Road Safety Audit - Peer Review

**Proposed Vehicle Access
at
626 Heidelberg Road, Alphington**

**Prepared For
Yarra City Council**

Our Reference: G24706R-04A

Figure 1: Proposed Access Arrangements

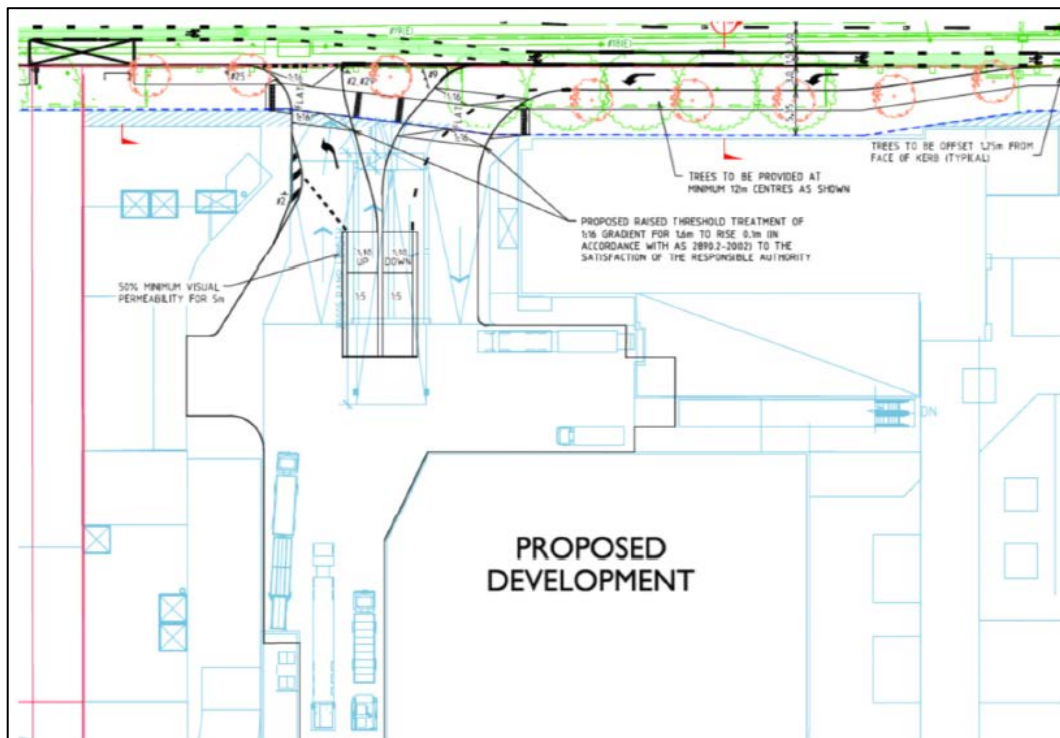
Road Safety Audits Pty – Identified Safety Issues		Traffix Group Review	
		Agree/ Disagree	Comments
1	<p><u>Issue:</u> Navigation</p> <p><i>'It is understood that the loading area will be distinguished from the car park access road with signs and line-marking. If drivers may be confused here there is potential for sudden stops and rear-end crashes. The Westfield Doncaster example shown in Figure 3 could be easily misunderstood due for faded pavement markings and gantry signage for the carpark only.'</i></p>	Agree	If the car and truck access points are not clearly signed there is potential for rear end crashes as drivers make last minute decisions.
	<p><u>Suggestion:</u></p> <p><i>'Ensure the loading bay area is clearly distinguished from the road – preferably by a different colour paving.'</i></p>	Agree	Agree that the loading bay should be clearly distinguished from the carpark access. However, there are multiple signage, linemarking or pavement options that could be applied (it doesn't necessarily have to be limited to a different coloured paving).

Road Safety Audits Pty – Identified Safety Issues		Traffix Group Review	
		Agree/ Disagree	Comments
2	<p><u>Issue:</u> Cyclists</p> <p><i>'With the level shared path threshold treatments, a concern is raised about the potential for cyclists on the shared path to approach at speeds higher than drivers expect or can easily give way to.</i></p> <p><i>Note: Based on Victorian Road Rules, SUP users have the right of way over entering vehicles (side road or driveway), and sometimes over exiting vehicles (driveway but not side road).'</i></p>	Agree	The proposed plans do not clearly highlight the priority at the raised shared path crossing point. This could lead to confusion between riders, pedestrians and drivers to who has right of way.
	<p><u>Suggestion:</u></p> <ul style="list-style-type: none"> • <i>'Check sight distance (including ensuring trees chosen will not be bushy below 2m).</i> • <i>Investigate measures to slow cyclists and to alert them.</i> • <i>As the Road Rules are not well understood on this point, consider actively providing priority to SUP users with signs and markings.'</i> 	Agree	<p>The plans should clearly show who has priority at the shared path crossing (bicycles / pedestrians or vehicles).</p> <p>The selection of appropriate vegetation around the crossing is also critical to maintain sight lines.</p>

Road Safety Audits Pty – Identified Safety Issues		Traffix Group Review	
		Agree/ Disagree	Comments
3	<u>Issue:</u> TGSIs '1. Some of the TGSIs are shown perpendicular to approach paths rather than crossing alignment (red circles). 2. TGSIs can be skidding hazards for cyclists. 3. Some projects get constructed with white TGSIs on light grey paths.'	Agree	The warning TGSIs should align with the path of travel. The currently arrangement would direct vision impaired pedestrians onto the ramp associated with the raised crossing.
	<u>Suggestion:</u> <ul style="list-style-type: none"> • 'Realign these TGSIs. • Specify TGSIs with similar friction characteristics to the surrounding path. • Ensure good contrast is provided.' 	Agree	The TGSIs should be updated to reflect the relevant Australian Standard.
	<u>Status:</u> No ranking provided	-	The previous Road Safety Audit doesn't provide a risk ranking for this item. Our ranking for this item is as follows: <u>Probability:</u> Improbable <u>Severity:</u> Minor <u>Risk Rating:</u> Low

Road Safety Audits Pty – Identified Safety Issues		Traffix Group Review	
		Agree/ Disagree	Comments
	<u>Issue:</u> Wall Hazard <i>If a wall is present between entering trucks and cars, it would be a roadside hazard (although speeds will be low).</i>	Agree	Whilst it is agreed that the wall does present a blunt end adjacent to the possible travel paths, the vehicle speeds within the site would be expected to be very low (i.e. carpark speeds).
	<u>Suggestion:</u> <i>Consider incorporating a shock absorbing bollard as shown.</i>	Agree	An energy absorbing bollard would address the issue of the wall hazard. Furthermore, improved delineation as described in Item 1 would assist with alignment of vehicles into the carpark access.
4	<u>Status:</u> No ranking provided	-	<p>The previous Road Safety Audit doesn't provide a risk ranking for this item. Our ranking for this item is as follows:</p> <p><u>Probability:</u> Improbable</p> <p><u>Severity:</u> Minor</p> <p><u>Risk Rating:</u> Low</p> <p>Whilst no ranking has been provided, we are of the view that this item has a low risk rating.</p>

Road Safety Audits Pty – Identified Safety Issues		Traffix Group Review	
		Agree/ Disagree	Comments
5	<u>Issue:</u> Sight Lines Between Vehicles Approaching Heidelberg Road <i>The wall between trucks and cars will obstruct sightlines between drivers of vehicles with conflicting movements. While a give way line is shown, truck drivers can only give way if they can see the vehicles they have to give way to.</i>	Agree	Whilst the plans do reference 50% visual permeability, it is agreed that further detail regarding the wall openings should be provided at future design stages.
	<u>Suggestion:</u> <i>50% visual permeability is specified. Ensure this visual permeability is relevant to the angles of viewing required.</i>	Agree	The plans already specify 50% visual permeability.
	<u>Status:</u> No ranking provided	Partial	The previous Road Safety Audit doesn't provide a risk ranking for this item. Our ranking for this item is as follows: <u>Probability:</u> Occasional <u>Severity:</u> Minor <u>Risk Rating:</u> Medium Given the medium ranking, this item should be given the appropriate weighting.

RSA Issue	Project Manager Response (GTA Consultants)		Traffix Group Review
	Accept / Reject	Comments / Status	
<p>1 <u>Issue: Navigation</u></p> <p><i>'It is understood that the loading area will be distinguished from the car park access road with signs and line-marking. Drivers may be confused here there is potential for sudden stops and rear-end crashes.</i></p> <p><i>The Westfield Doncaster example shown in Figure 3 could be easily misunderstood due for faded pavement markings and gantry signage for the carpark only.'</i></p> <p><u>Suggestion:</u></p> <p><i>'Ensure the loading bay area is clearly distinguished from the road – preferably by a different colour paving.'</i></p>	Accept	<p><i>It is expected that different coloured paving will be provided to differentiate the public car park to the loading area.</i></p> <p><i>It should be noted that the public ramp has been sufficiently set back from Heidelberg Road to allow motorists time to enter the car park.</i></p> <p><i>Additionally, signage will clearly identify the entrance to the car park, with the loading area to be gated (both entry and exit) for loading vehicles only.</i></p>	<p>The proposed actions address the proposed safety concerns, in particular the usage of gates for the entry and exit of the loading area will clearly define the access path for general vehicles.</p> <p>However, the architectural plans submitted to Council do not show any of the detail proposed to address this item (signs, pavement treatment, linemarking or gates).</p> <p>Recommendation: Seek plans from the proponent showing the suggested improvements.</p>

<p>2 <u>Issue: Cyclists</u></p> <p><i>'With the level shared path threshold treatments, a concern is raised about the potential for cyclists on the shared path to approach at speeds higher than drivers expect or can easily give way to.</i></p> <p><i>Note: Based on Victorian Road Rules, SUP users have the right of way over entering vehicles (side road or driveway), and sometimes over exiting vehicles (driveway but not side road).'</i></p> <p><u>Suggestion:</u></p> <ul style="list-style-type: none"> <i>'Check sight distance (including ensuring trees chosen will not be bushy below 2m).</i> <i>Investigate measures to slow cyclists and to alert them.</i> <i>As the Road Rules are not well understood on this point, consider actively providing priority to SUP users with signs and markings.'</i> 	Reject	<p><i>Along the site frontage on Heidelberg Road, both an on-road bicycle lane and a shared path are proposed to be provided in accordance with the Development Plan for the overall site.</i></p> <p><i>As such, it is expected that competent cyclists (travelling at speed) will chose to utilise the on-road bicycle lane, with less experienced users expected to utilise the shared path at slower speeds.</i></p> <p><i>Notwithstanding the above, the canopy of the street trees are proposed to be greater than 2m to aid sight distance for motorists.</i></p>	<p>The response addresses the sight lines issues associated with the proposed landscaping, with trees with a higher canopy than 2m to be utilised.</p> <p>However, the response does not address the issue of shared path priority. The discussion simply indicates that less experienced riders would be using the path. We are of the view that it is therefore even more important that the priority is clear to drivers and riders.</p> <p>Recommendation: Ask the proponent to clearly define the shared path priority.</p>

RSA Issue	Project Manager Response (GTA Consultants)		Traffix Group Review
	Accept / Reject	Comments / Status	
<p>3 <u>Issue:</u> TGSIs</p> <p>'1. Some of the TGSIs are shown perpendicular to approach paths rather than crossing alignment (red circles).</p> <p>2. TGSIs can be skidding hazards for cyclists.</p> <p>3. Some projects get constructed with white TGSIs on light grey paths.'</p> <p><u>Suggestion:</u></p> <ul style="list-style-type: none"> • 'Realign these TGSIs. • Specify TGSIs with similar friction characteristics to the surrounding path. • Ensure good contrast is provided.' 	Accept	The functional layout plan can be updated to include a realignment of the TGSI's.	<p>The project manager has accepted the suggestion to realign the pram ramps. However, both the architectural plans and functional layout provided in the GTA report do not show the pram ramps being realigned.</p> <p>Recommendation: Seek plans from the proponent showing the suggested improvements.</p>

<p>4 <u>Issue:</u> Wall Hazard</p> <p>If a wall is present between entering trucks and cars, it would be a roadside hazard (although speeds will be low).</p> <p><u>Suggestion:</u></p> <p>Consider incorporating a shock absorbing bollard as shown.</p>	Accept	The functional layout plan can be updated to include a bollard as suggested.	<p>The project manager has accepted the suggestion to include a bollard in front of the wall. However, bot the architectural plans and functional layout provided in the GTA report do not show the bollard included.</p> <p>Recommendation: Seek plans from the proponent showing the suggested improvements.</p>

RSA Issue	Project Manager Response (GTA Consultants)		Traffix Group Review
	Accept / Reject	Comments / Status	
<p>5 <u>Issue:</u> Sight Lines Between Vehicles Approaching Heidelberg Road</p> <p>The wall between trucks and cars will obstruct sightlines between drivers of vehicles with conflicting movements. While a give way line is shown, truck drivers can only give way if they can see the vehicles they have to give way to.</p> <p><u>Suggestion:</u></p> <p>50% visual permeability is specified. Ensure this visual permeability is relevant to the angles of viewing required.</p>	Accept	The wall between trucks and cars will be 50% permeable for exiting cars/trucks at this location.	<p>The plans provided as part of the previous RSA included text for the wall to be 50% clear of visual obstructions. This action would address the identified safety issue.</p> <p>The plans provided as part of the planning permit submission do not show this note. It is important that this design detail is not lost at the detailed design stage.</p> <p>Recommendation: Ensure that the note for 50% permeability is provided</p>

Figure 2: Design which is the subject of this audit

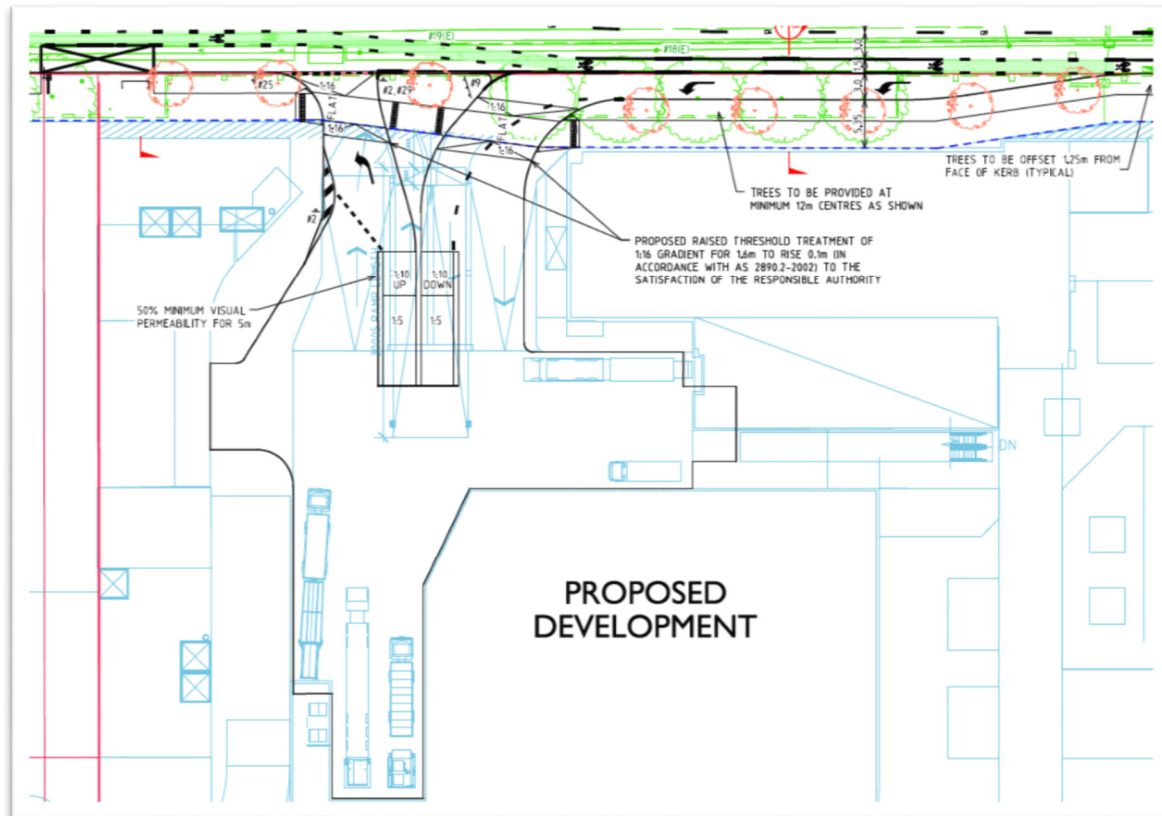
Point No.	Issue	Suggestion	Response	
			Accept / Reject	Comment / Status
1.	Navigation It is understood that the loading area will be distinguished from the car park access road with signs and line-marking. If drivers may be confused here there is potential for sudden stops and rear-end crashes. The Westfield Doncaster example shown in Figure 3 could be easily misunderstood due for faded pavement markings and gantry signage for the carpark only.	Ensure the loading bay area is clearly distinguished from the road – preferably by a different colour paving. Status: Compliance / NA / Urgent / Important / Minor	Accept	It is expected that different coloured paving will be provided to differentiate the public car park to the loading area. It should be noted that the public ramp has been sufficiently set back from Heidelberg Road to allow motorists time to enter the car park. Additionally, signage will clearly identify the entrance to the car park, with the loading area to be gated (both entry and exit) for loading vehicles only.

2.	Cyclists With the level shared path threshold treatments, a concern is raised about the potential for cyclists on the shared path to approach at speeds higher than drivers expect or can easily give way to. Note: Based on Victorian Road Rules, SUP users have the right of way over entering vehicles (side road or driveway), and sometimes over exiting vehicles (driveway but not side road).	<ul style="list-style-type: none"> Check sight distance (including ensuring trees chosen will not be bushy below 2m). Investigate measures to slow cyclists and to alert them. As the Road Rules are not well understood on this point, consider actively providing priority to SUP users with signs and markings. Status: Compliance / NA / Urgent / Important / Minor	Reject	Along the site frontage on Heidelberg Road, both an on-road bicycle lane and a shared path are proposed to be provided in accordance with the Development Plan for the overall site. As such, it is expected that competent cyclists (travelling at speed) will choose to utilise the on-road bicycle lane, with less-experienced users expected to utilise the shared path at slower speeds. Notwithstanding the above, the canopy of the street trees are proposed to be greater than 2m to aid sight distance for motorists.

Point No.	Issue	Suggestion	Response	
			Accept / Reject	Comment / Status
3.	TGSIs <ol style="list-style-type: none"> Some of the TGSIs are shown perpendicular to approach paths rather than crossing alignment (red circles). TGSIs can be skidding hazards for cyclists. Some projects get constructed with white TGSIs on light grey paths. 	<ol style="list-style-type: none"> Realign these TGSIs. Specify TGSIs with similar friction characteristics to the surrounding path. Ensure good contrast is provided. 	Accept	The functional layout plan can be updated to include a realignment of the TGSI's.

Point No.	Issue	Suggestion	Response	
			Accept / Reject	Comment / Status
5.	Sightlines between vehicles approaching Heidelberg Rd The wall between trucks and cars will obstruct sightlines between drivers of vehicles with conflicting movements. While a give way line is shown, truck drivers can only give way if they can see the vehicles they have to give way to.	50% visual permeability is specified. Ensure this visual permeability is relevant to the angles of viewing required.	Accept	The wall between trucks and cars will be 50% permeable for exiting cars/trucks at this location.

6.	Swept paths Swept path drawings were not provided.	Ensure swept path checks are undertaken for all expected vehicles.	Accept	Swept paths for all relevant design vehicles in this area have been undertaken.

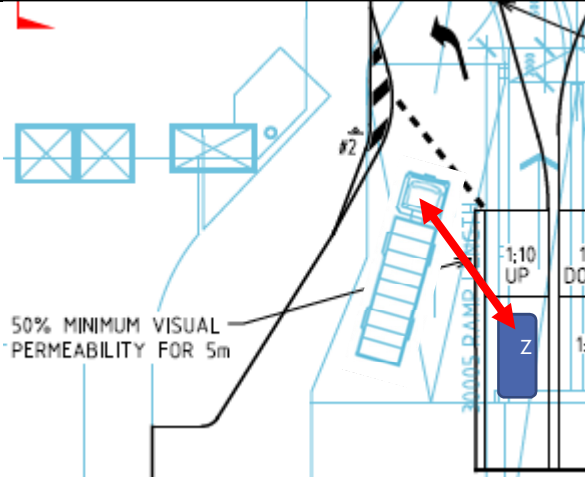
4.	Wall hazard <p>If a wall is present between entering trucks and cars, it would be a roadside hazard (although speeds will be low).</p>	Consider incorporating a shock absorbing bollard as shown.	Accept	The functional layout plan can be updated to include the bollard as suggested.
